North Dakota Department of Transportation

ADDENDUM 1 – JOB 2

TO: All prospective bidders on projects SOIA-7-085(096)192, Job No. 2 scheduled for the May 22, 2014 bid opening.

SRF No. 7594

Revised 5/12/2014	STATE	PROJECT NO.	SECTION NO.	SHEET NO.
	ND	SOIA-7-085(096)192	200	13

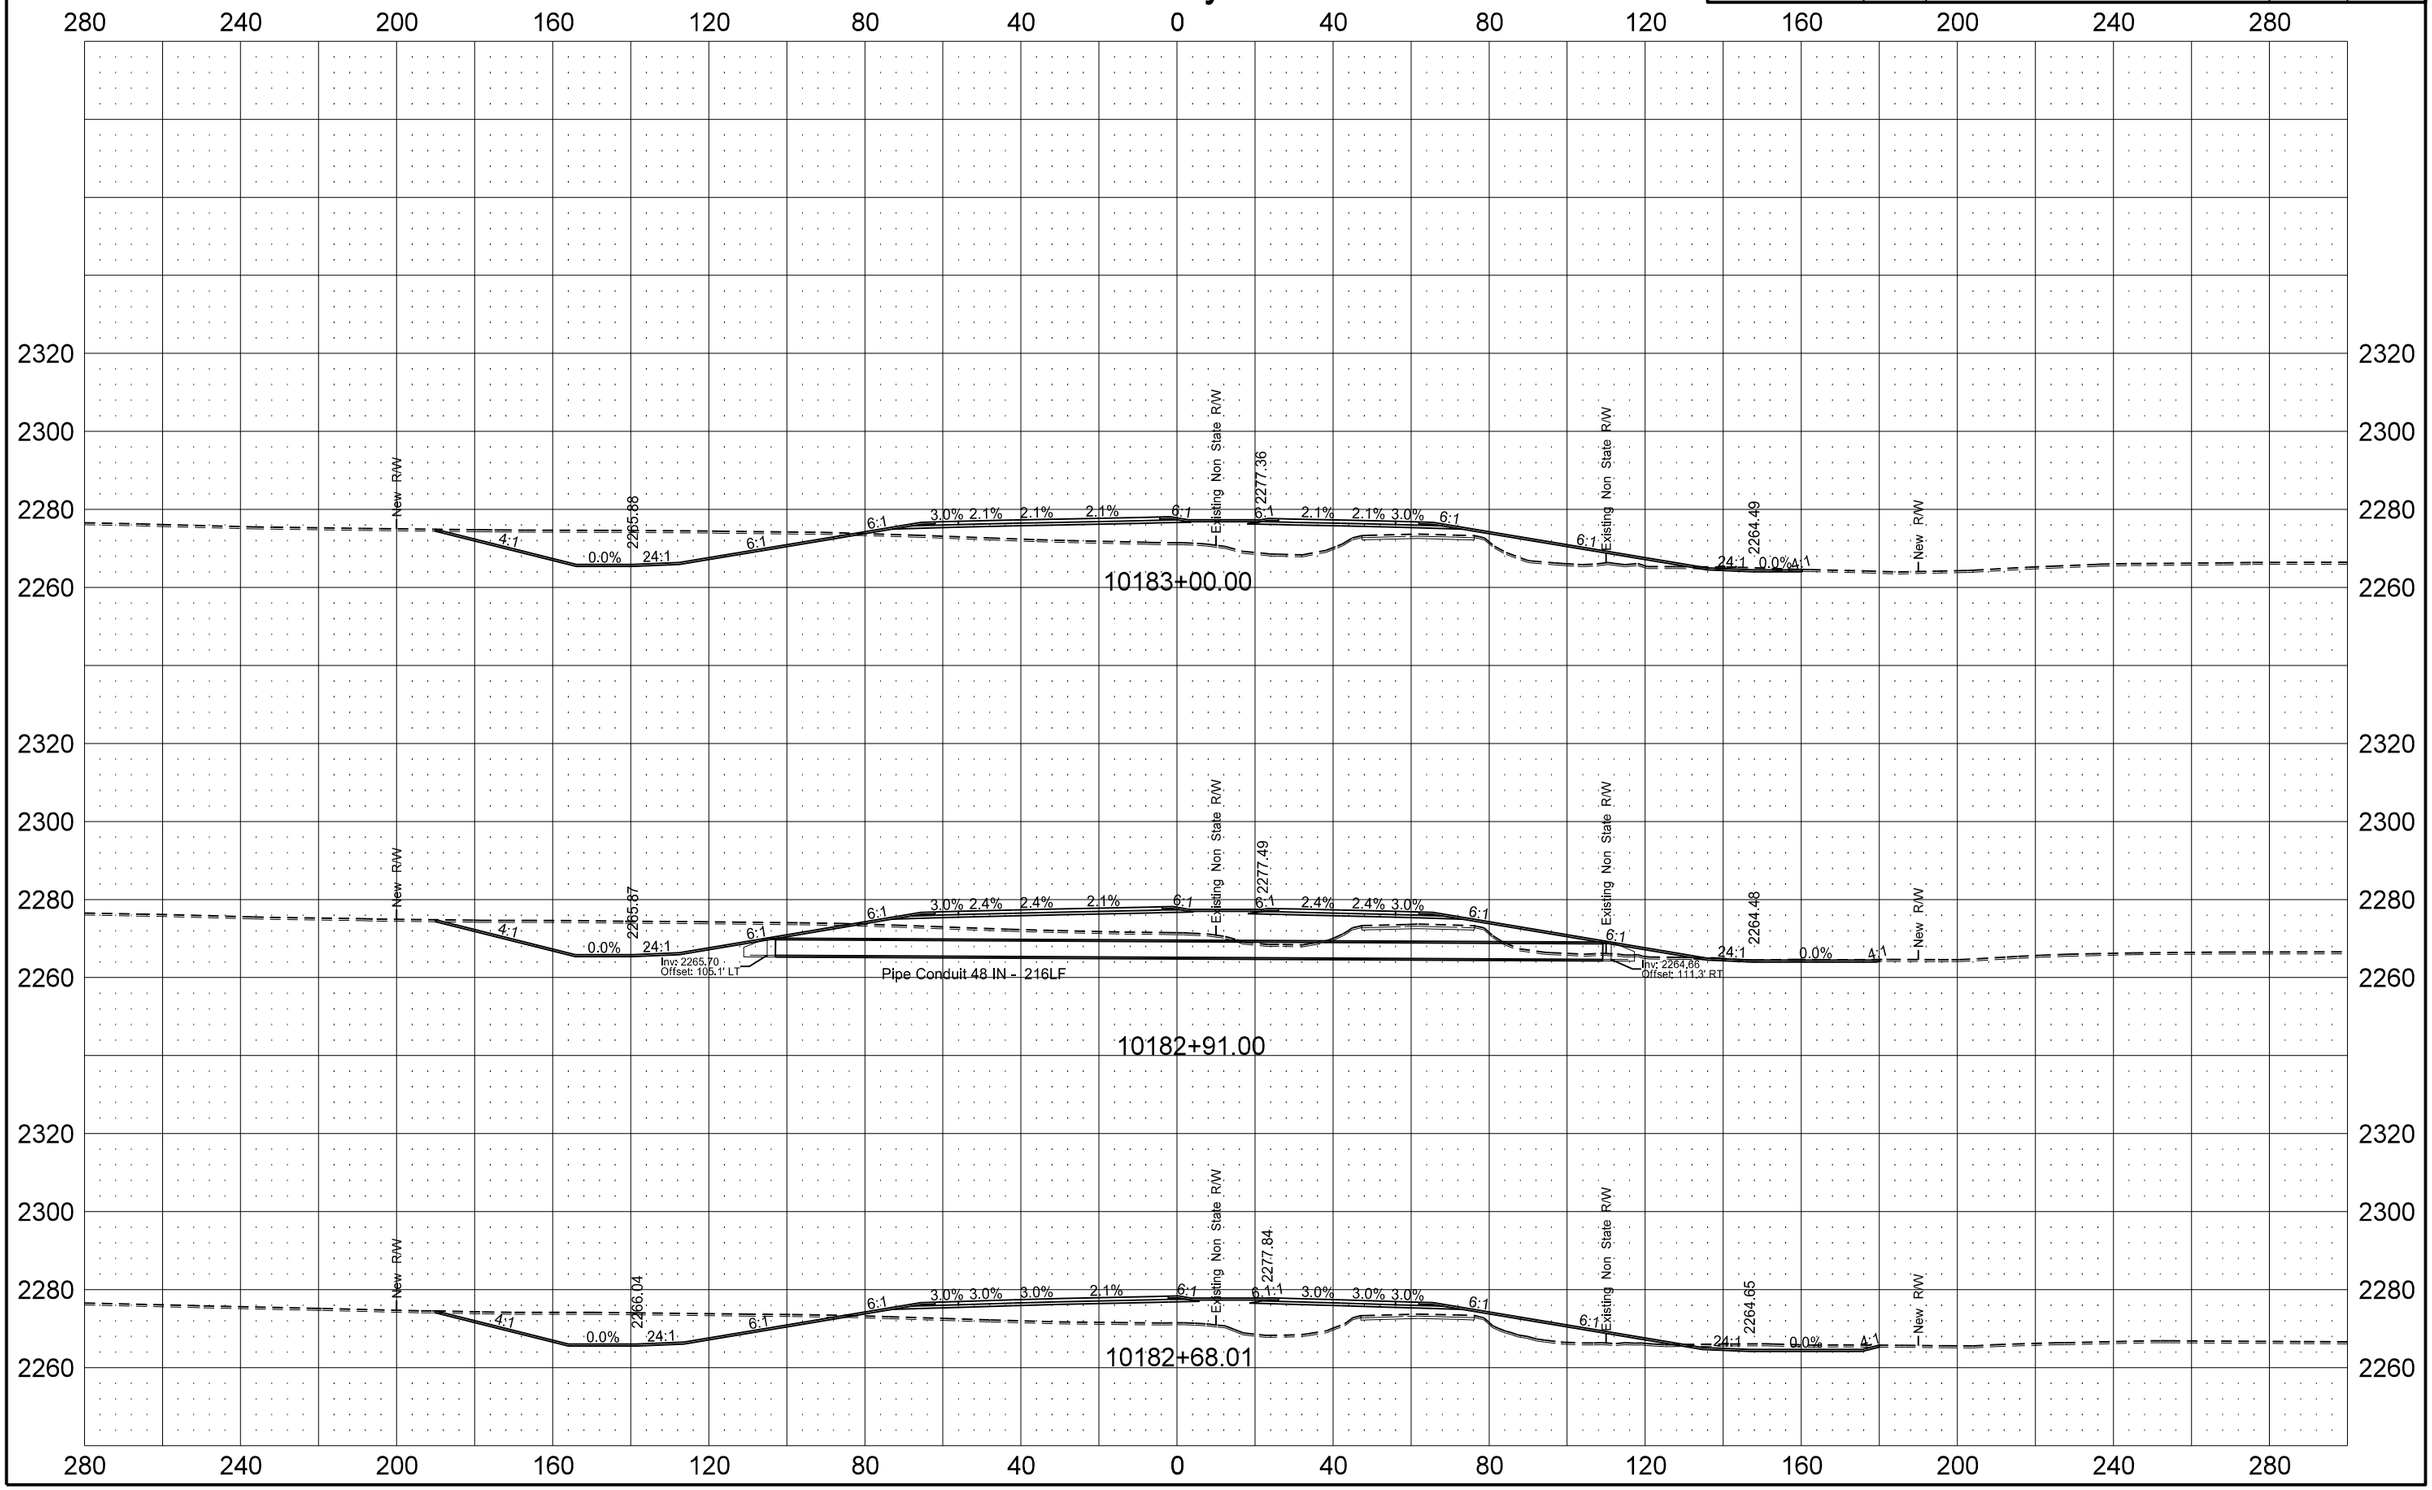
Sheet 200-13:
Revised pipe 10182+91 due to increase in drainage area.

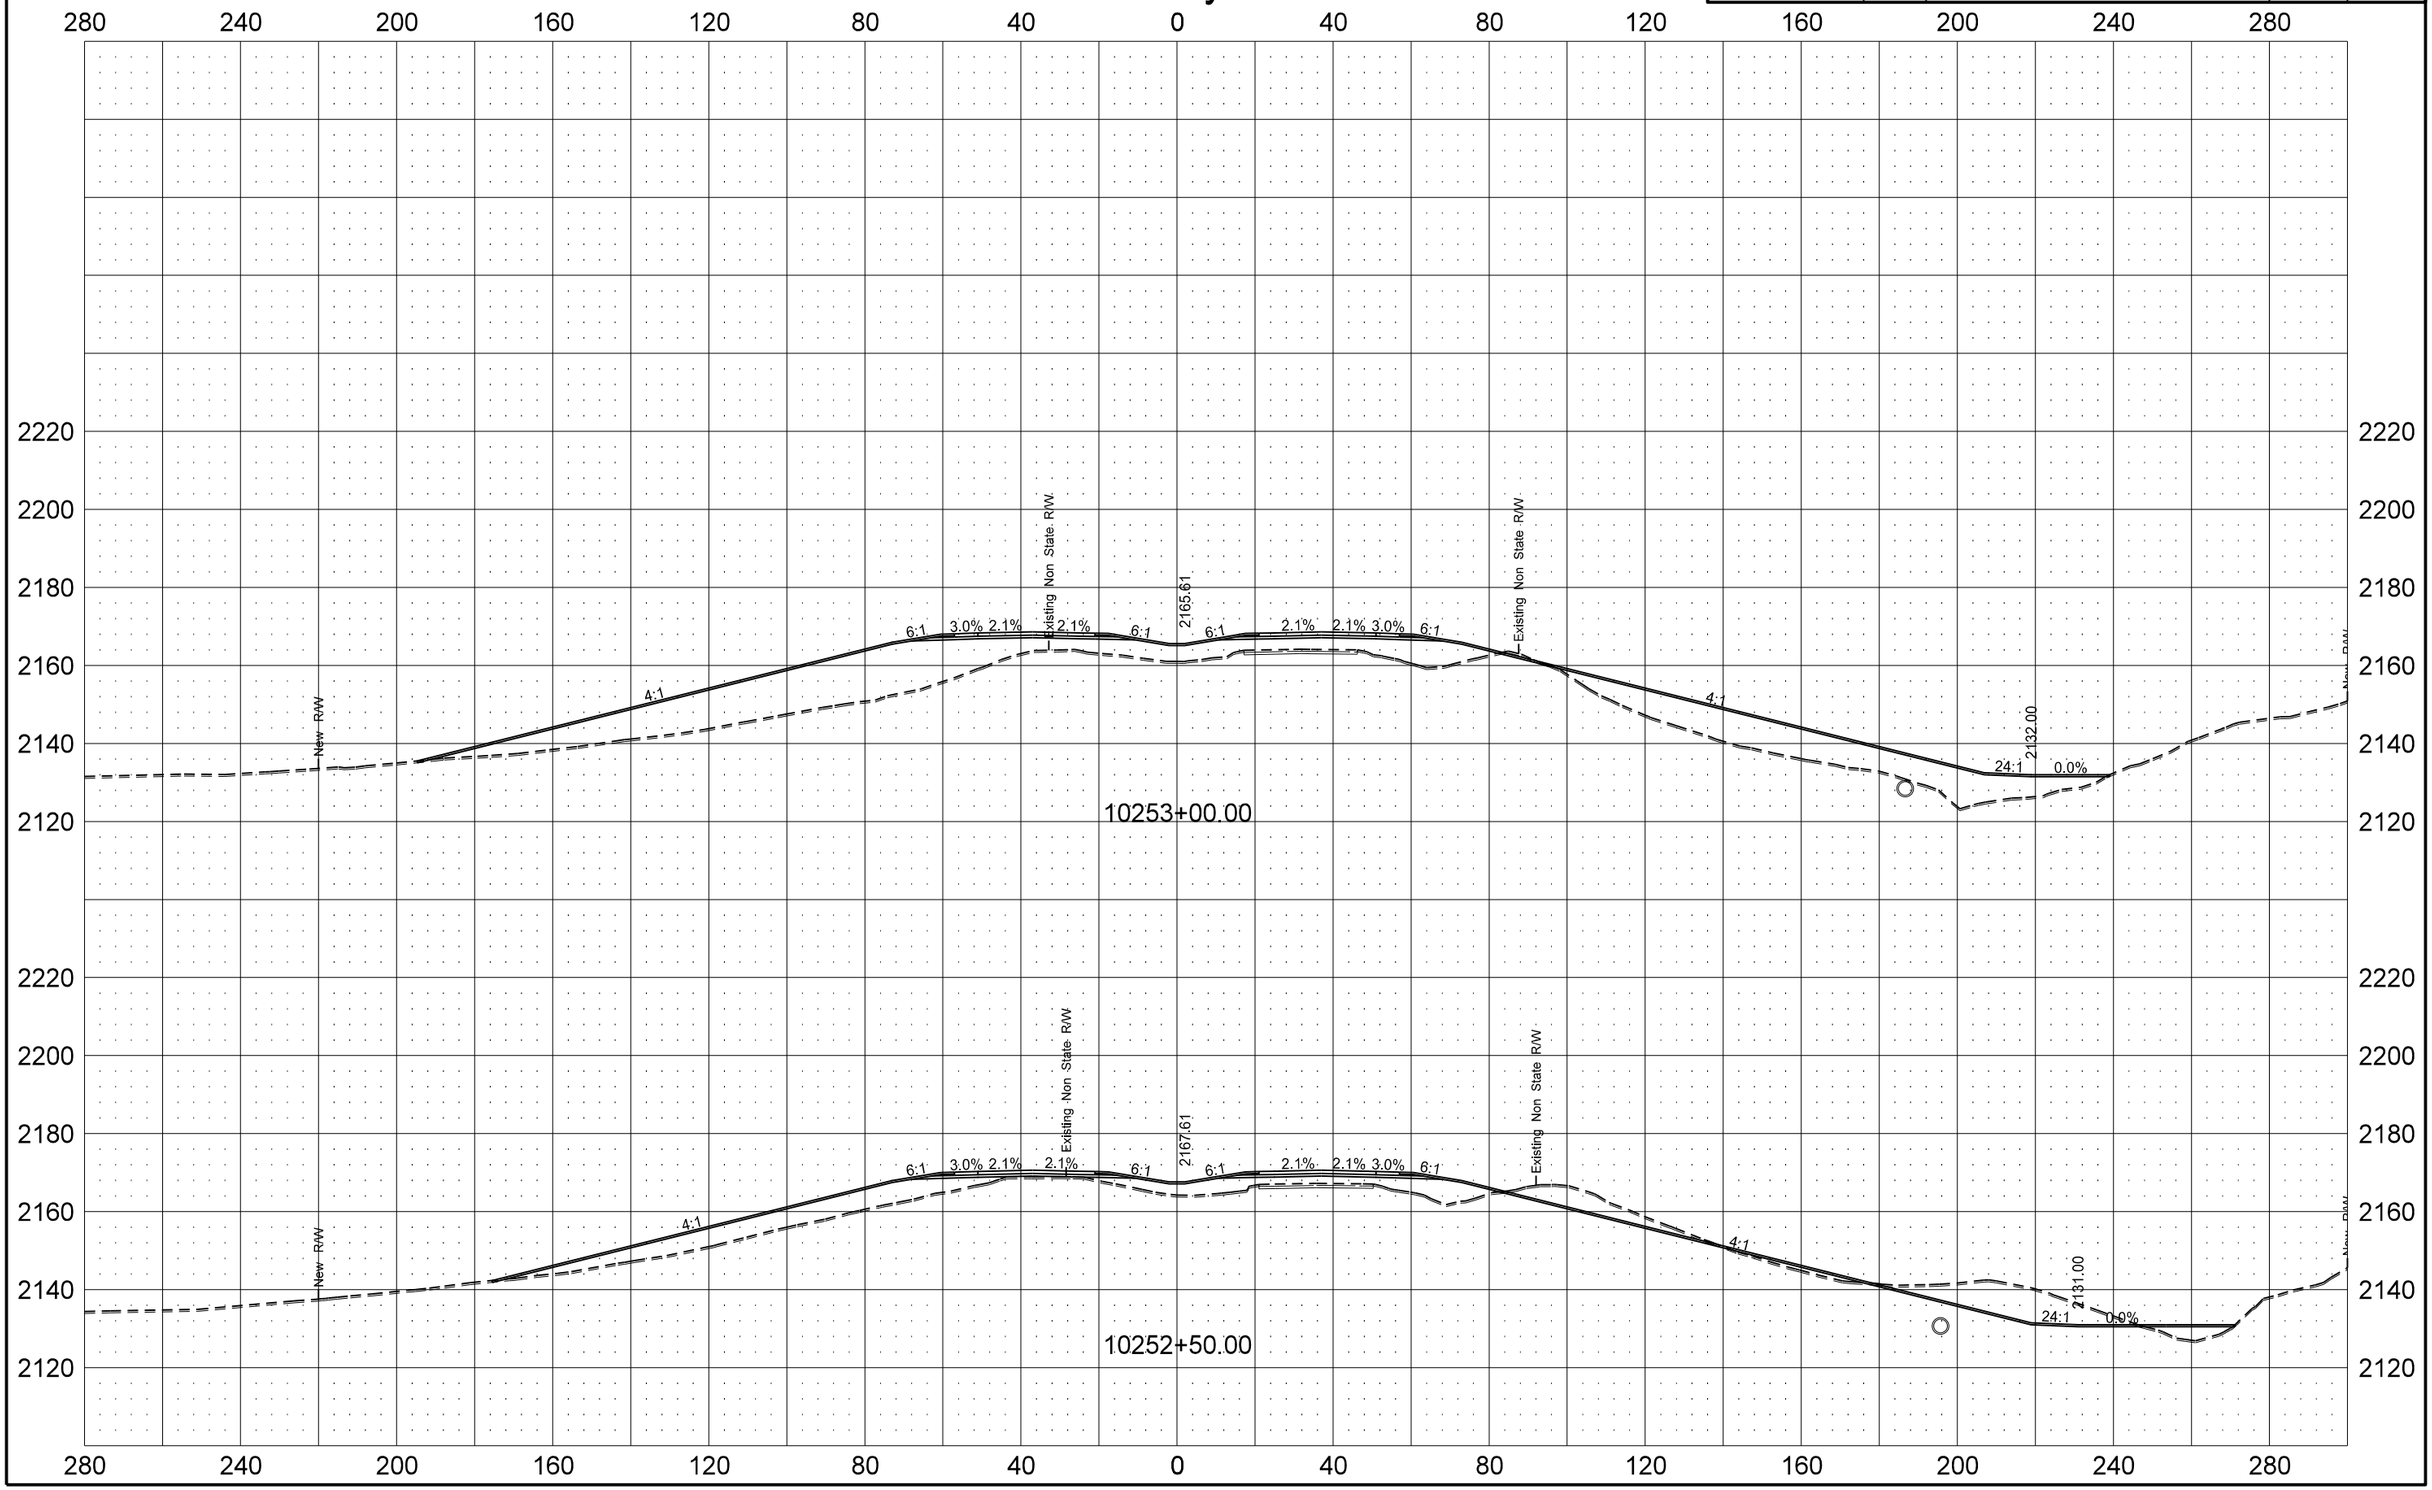
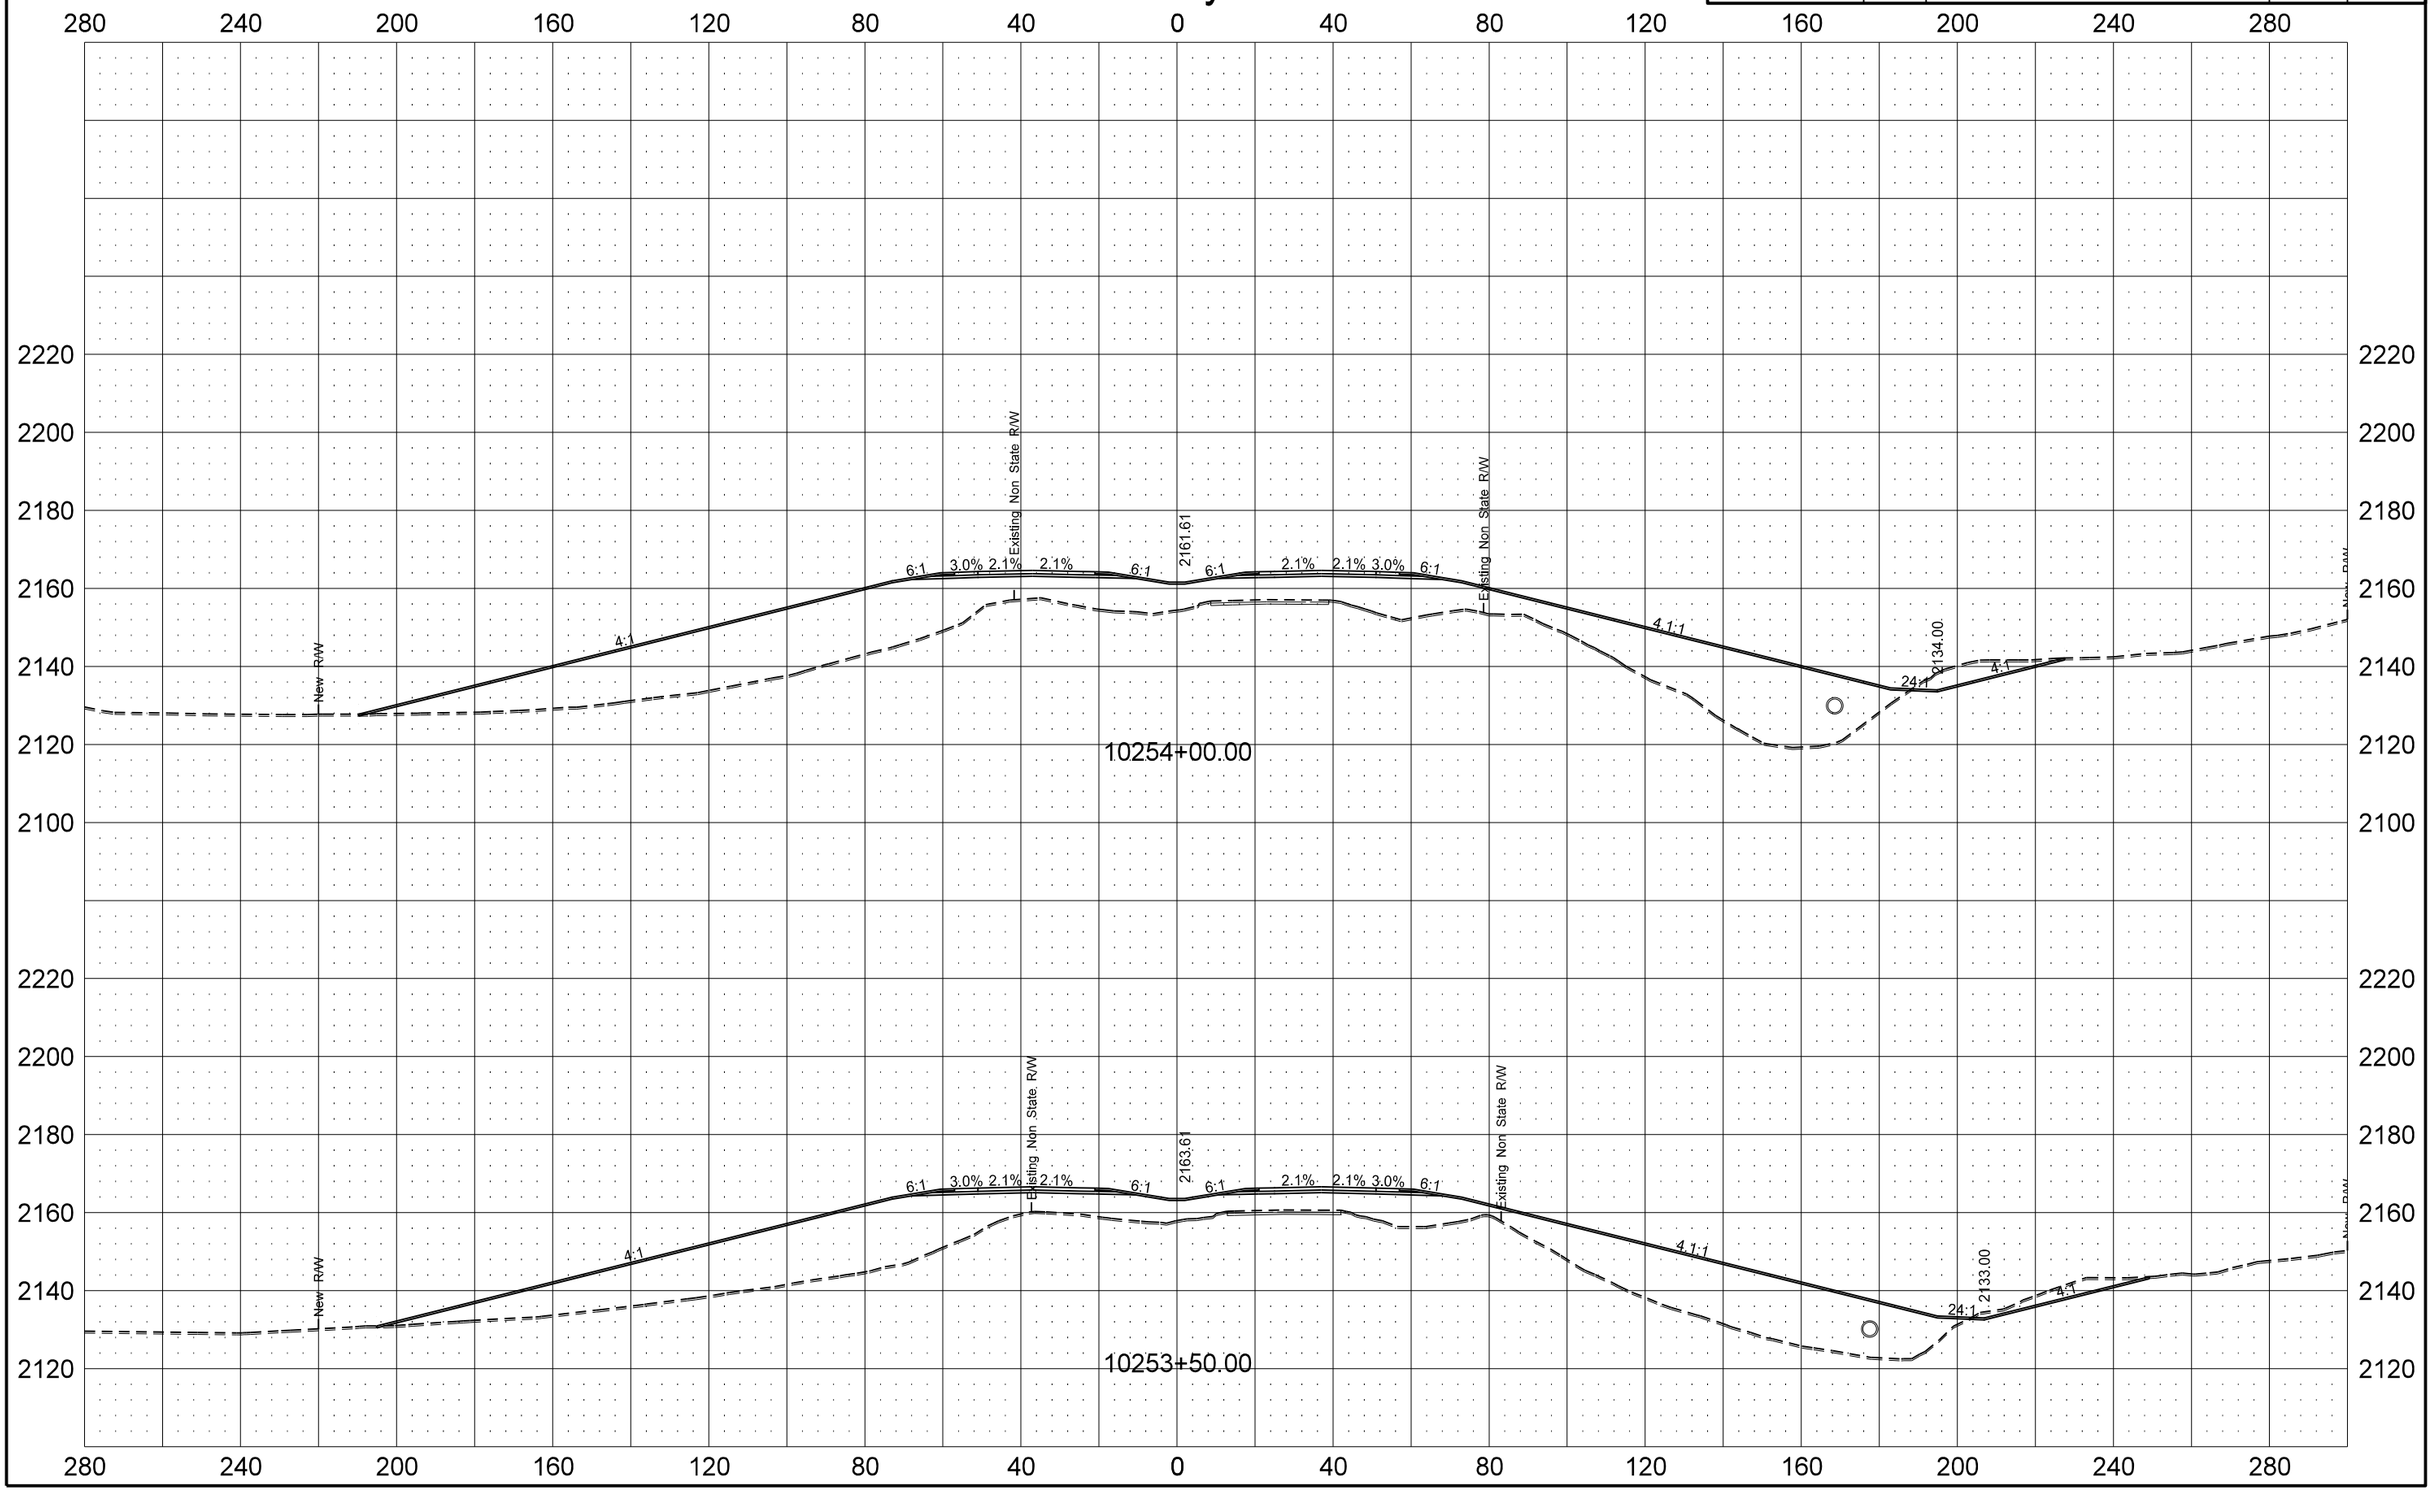
Sheets 200-78 through 200-107:
Revised cross sections due to change in retaining wall.
